ADDENDUM NO. 02
4 June 2009

Project: **THE NEW TEXAS CITY HIGH SCHOOL**
Texas City Independent School District

Bay Project No.: **0748**

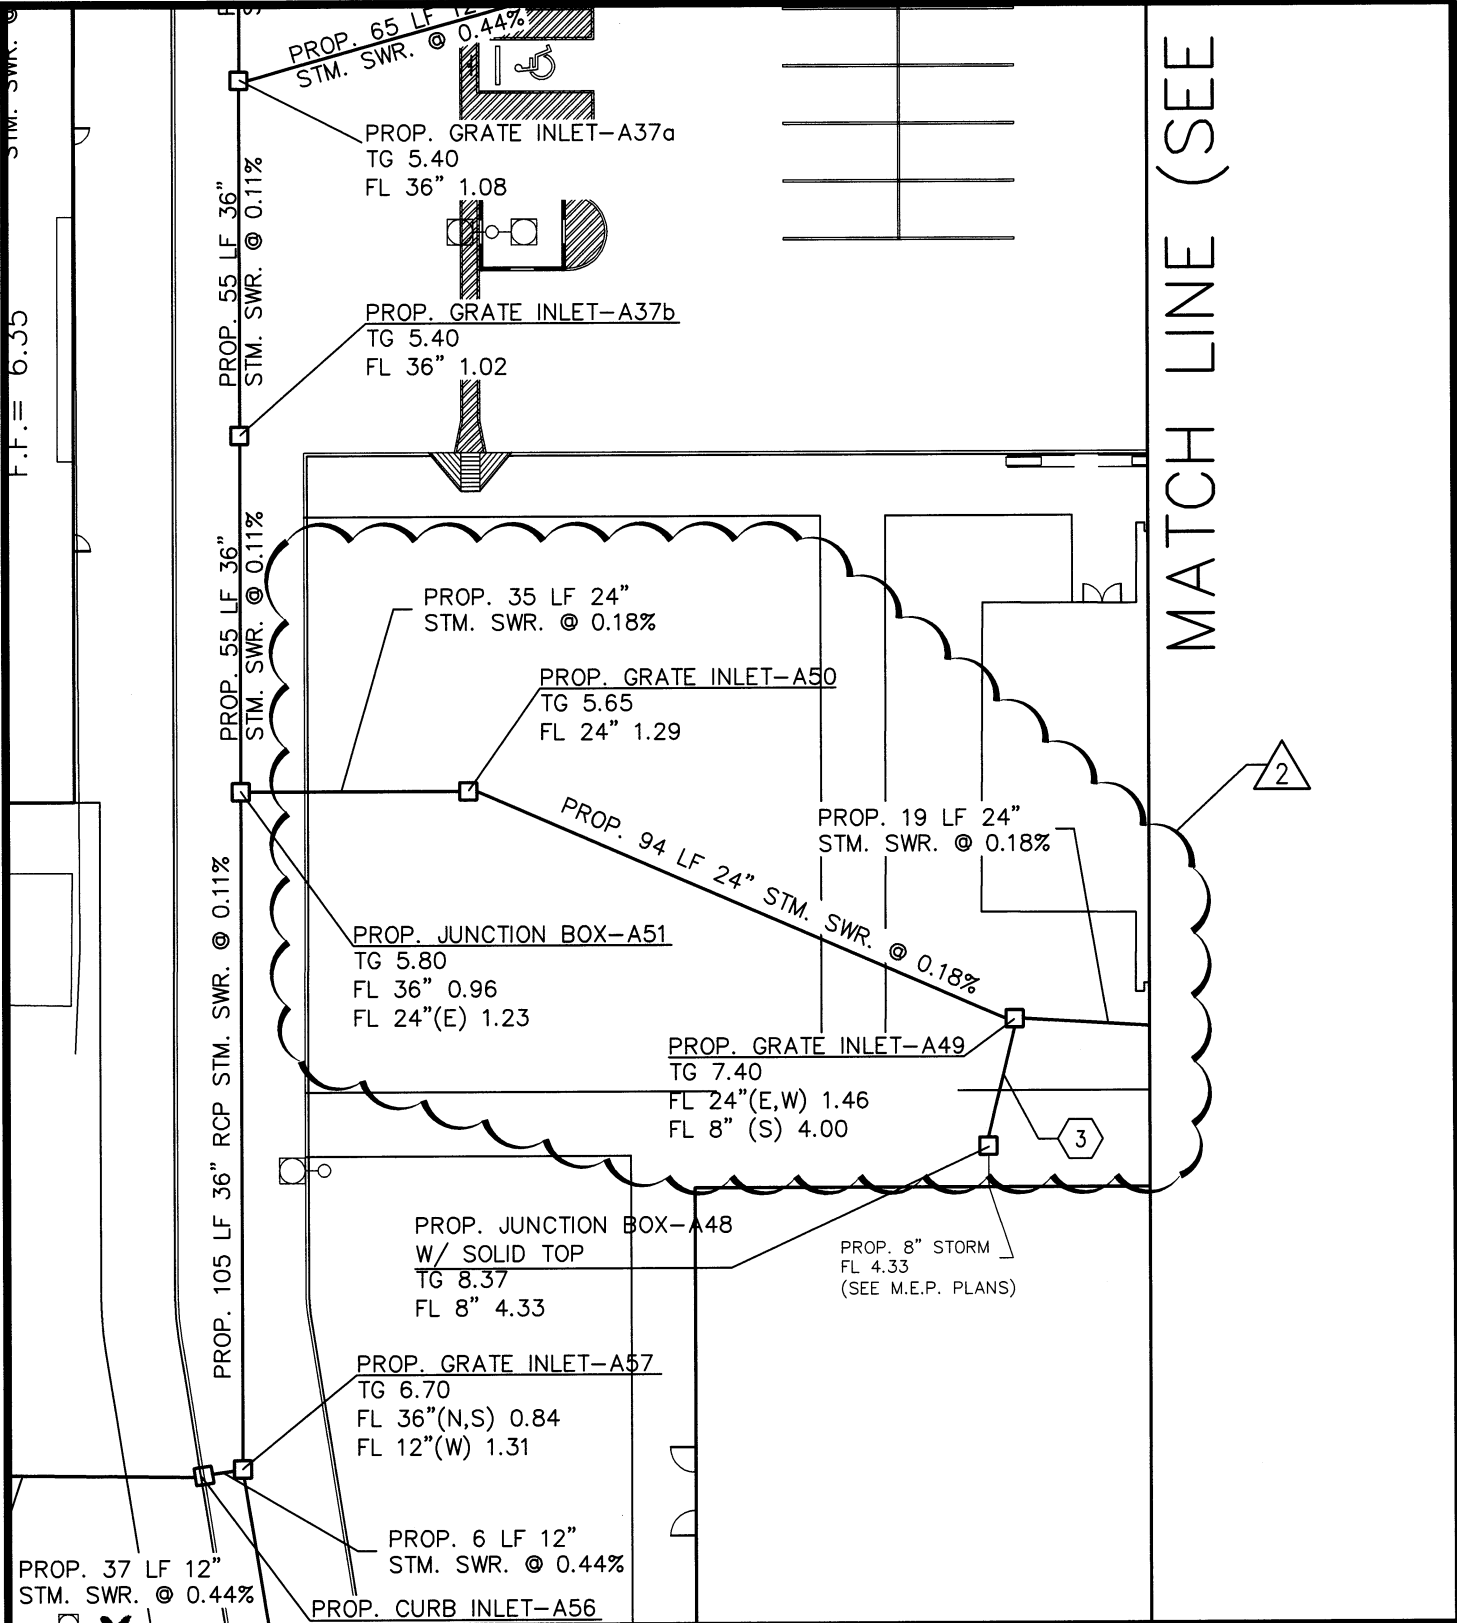
8. Sheet C2.13: Sketch **2-SKT-1** Upsize proposed storm sewer from 12” to 24” to run storm trunk between proposed building and existing field house.

ADDENDUM #
2-SKT-2

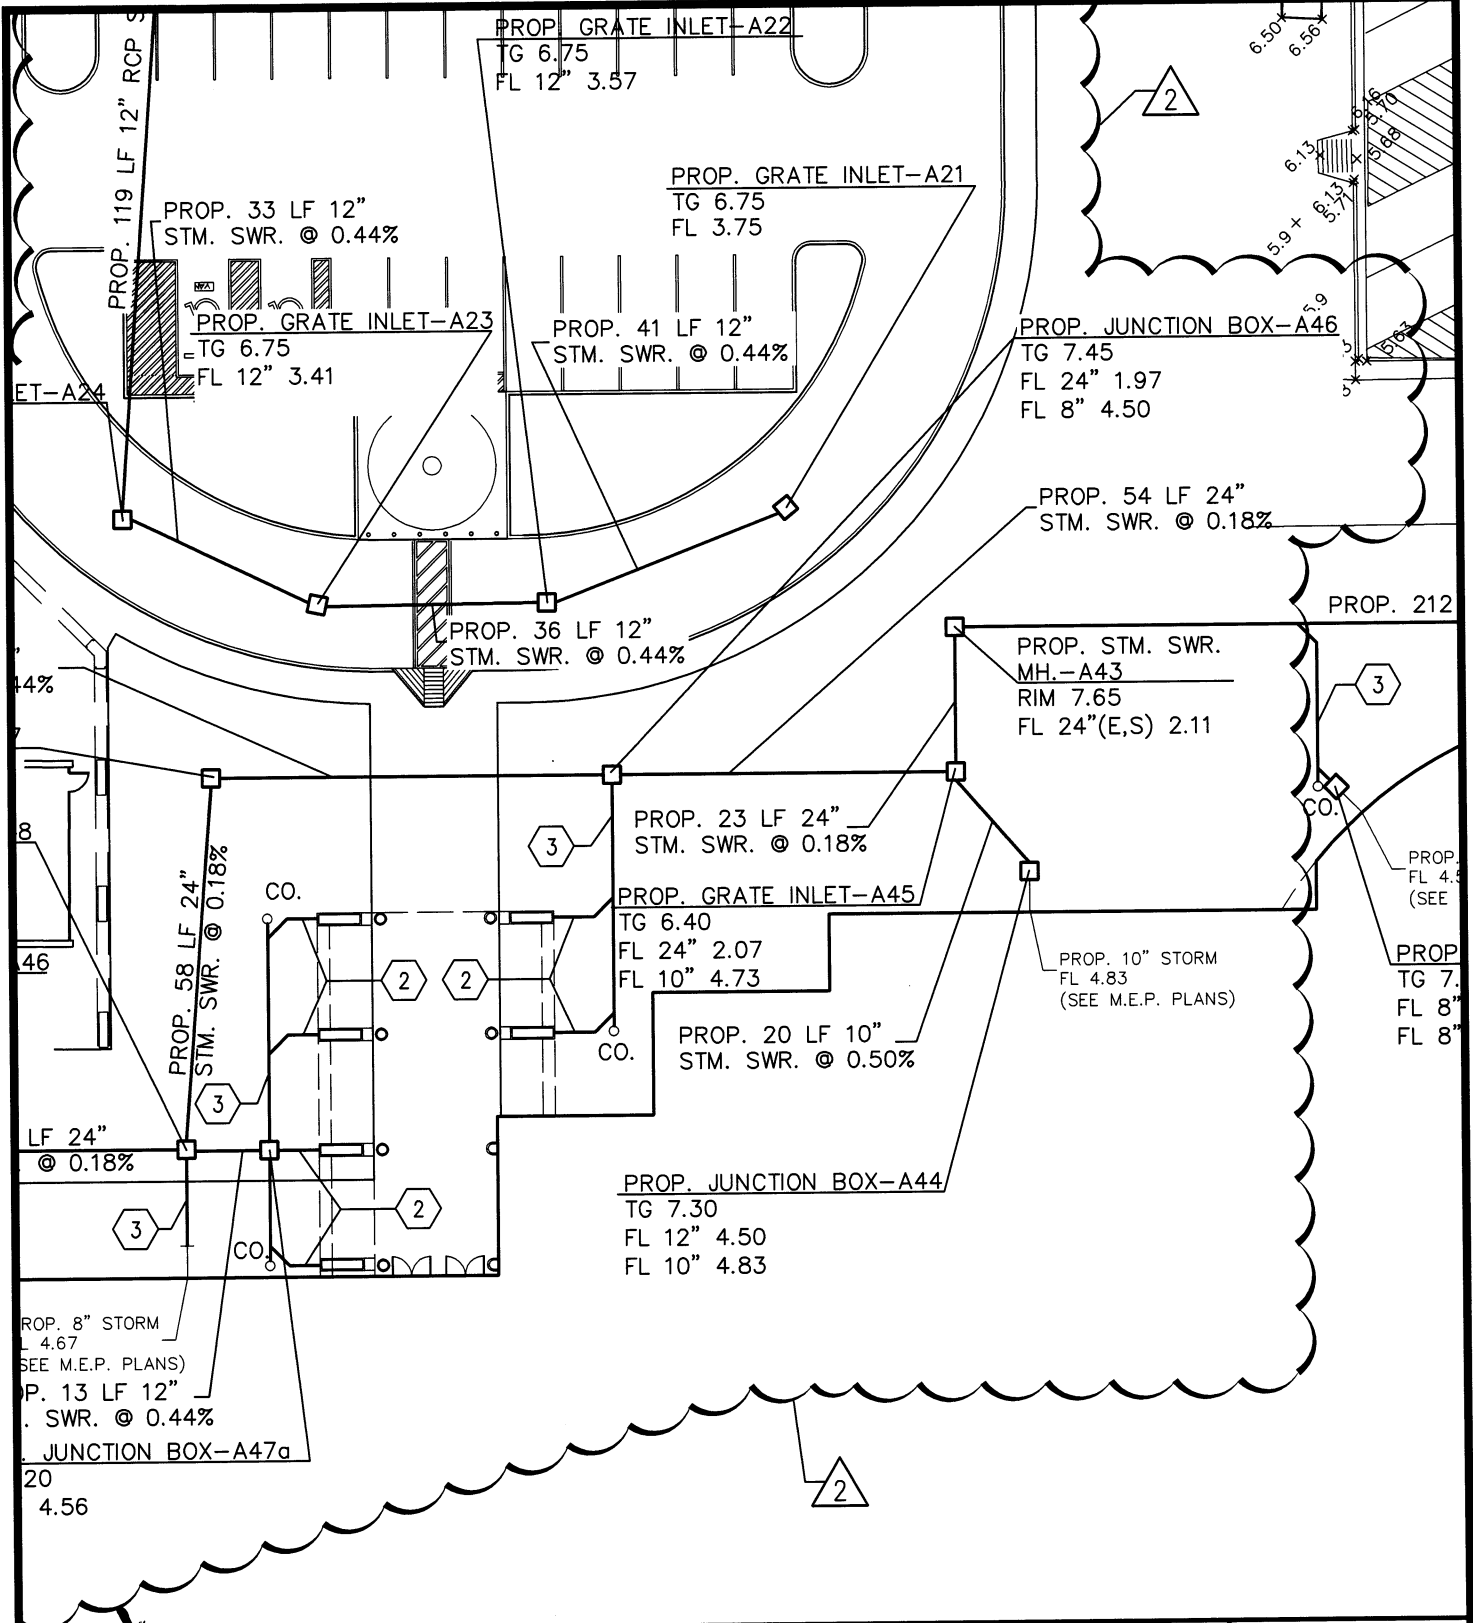
9. Sheet C2.13A: Sketch **2-SKT-2** Same revision as sketch 2-SKT-1. (revise alternate sheet to match calls as on bid sheet).
10. Sheet C2.14: Sketch **2-SKT-3** Reroute storm sewer trunk to run between proposed building and existing field house for construction phasing purposes. Add storm sewer piping to collect canopy drains at front entrance. Add two junction boxes to collect sub-surface drainage from canopy drains.

SCALE: 1"=30'	ADDENDUM # 2-SKT-4
DATE: 06-03-09	SHEET NO.: C2.14

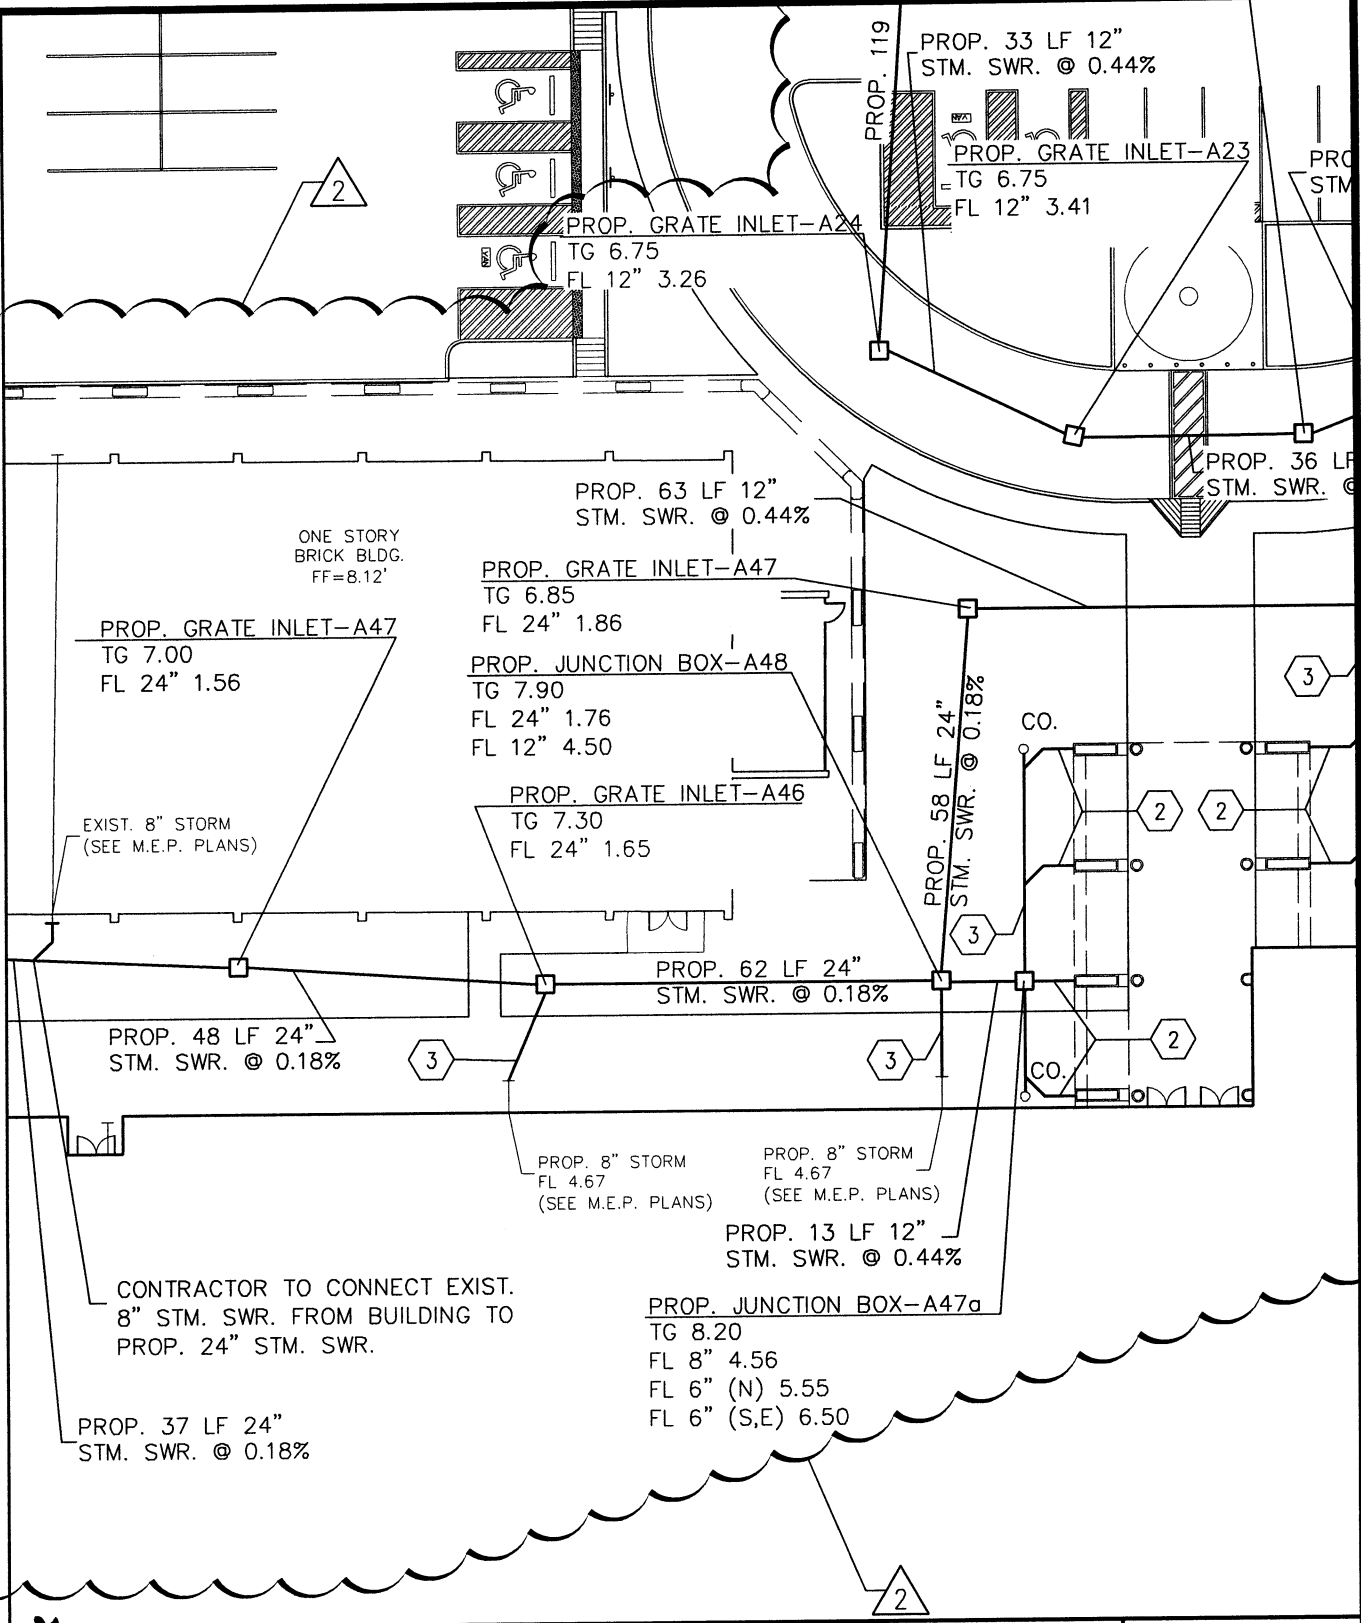
11. Sheet C2.14: Sketch **2-SKT-4** Revise sizes of storm sewer in parking lot from 24” to 12” and revise slopes and sizes accordingly.
12. Sheet C2.14: Sketch **2-SKT-5** Reroute storm sewer trunk to run between proposed building and existing field house for construction phasing purposes. Add storm sewer piping to collect canopy drains at front entrance. Add two junction boxes to collect sub-surface drainage from canopy drains.
